# 400GBASE-DR4-2 compliance to 400GBASE-DR4 and interoperability

Piers Dawe, Nvidia

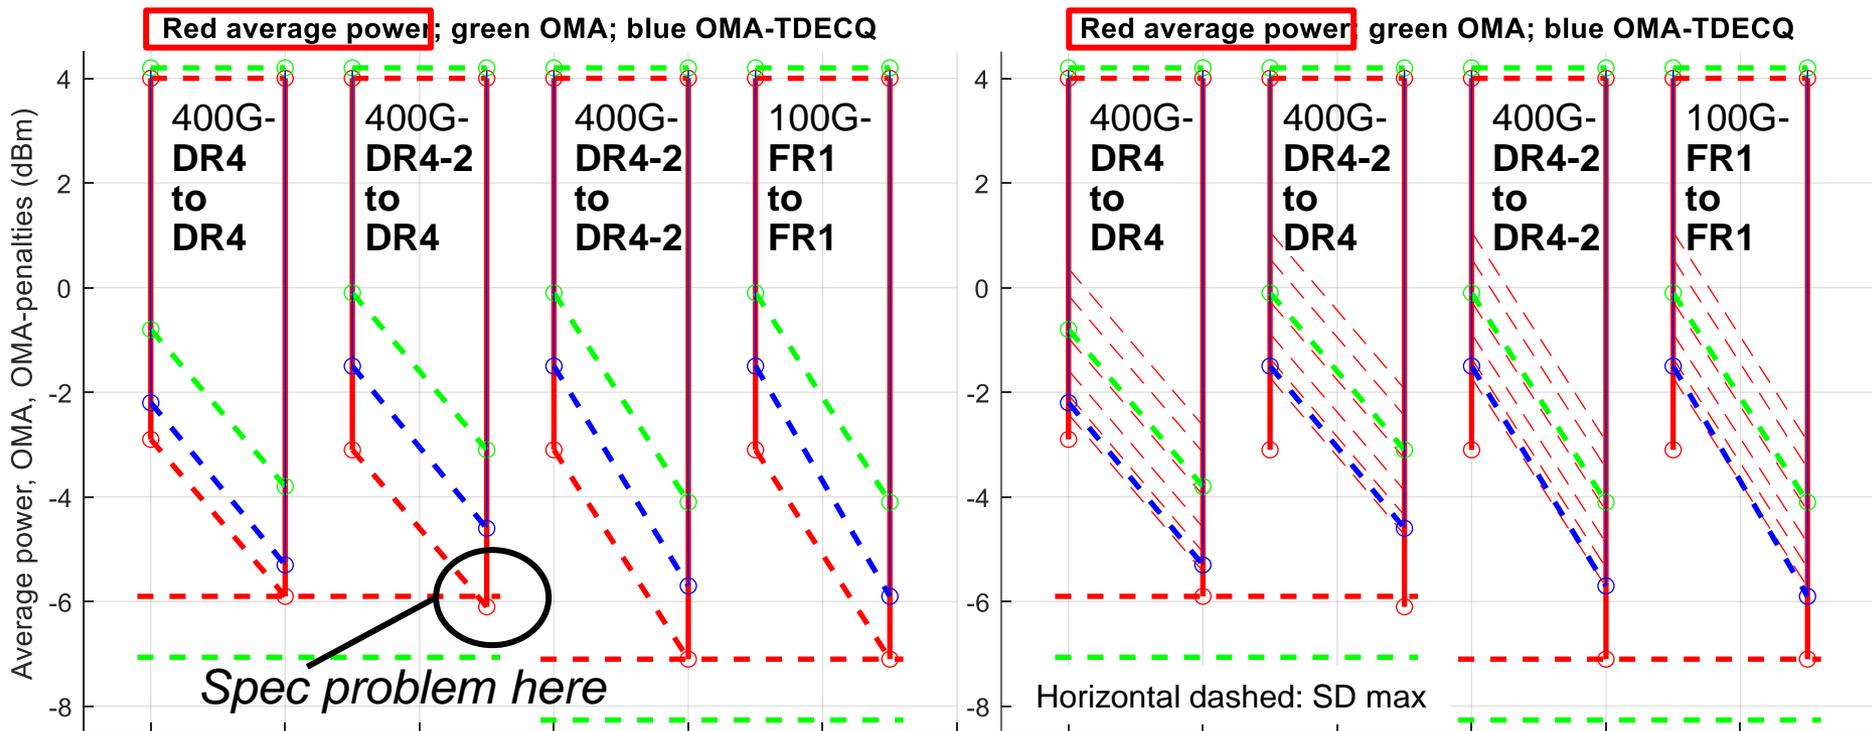
- Left: spec limits
- Right: 3.5, 4:8 dB ext. ratio
- Assumes that comment 15 (400GBASE-DR4-2 and 800GBASE-DR8-2, change the allocation for penalties) is accepted

# Solutions

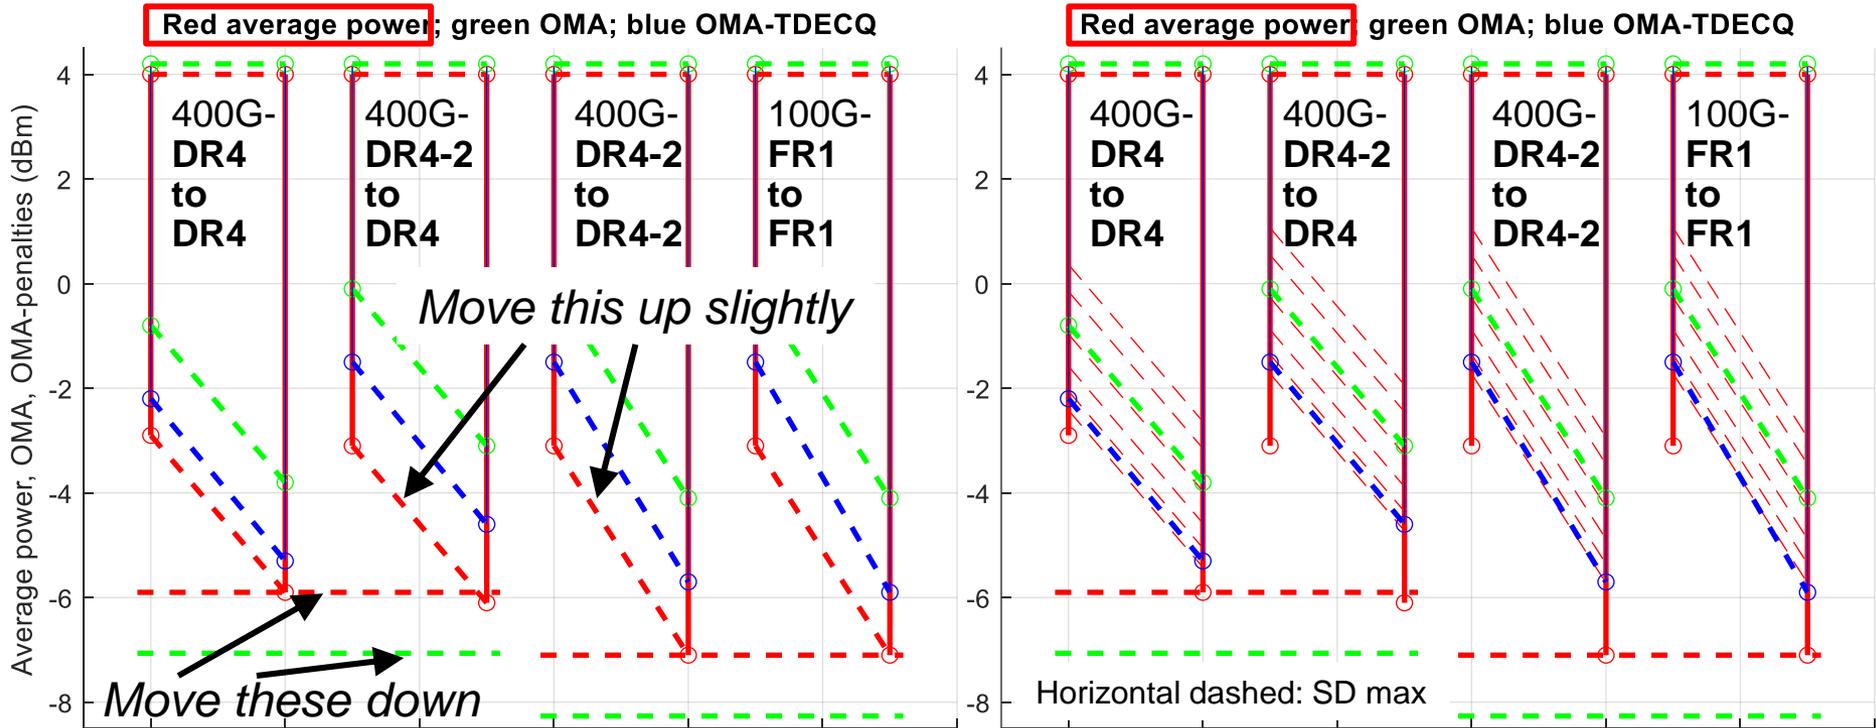
- Left: spec limits
- Right: 3.5, 4:8 dB ext. ratio
- Increase 400GBASE-DR4-2, 800GBASE-DR8-2 average power for 400GBASE-DR4 compliance
- Reduce 400GBASE-DR4-2, 800GBASE-DR8-2 SD max for 100GBASE-FR1 compatibility
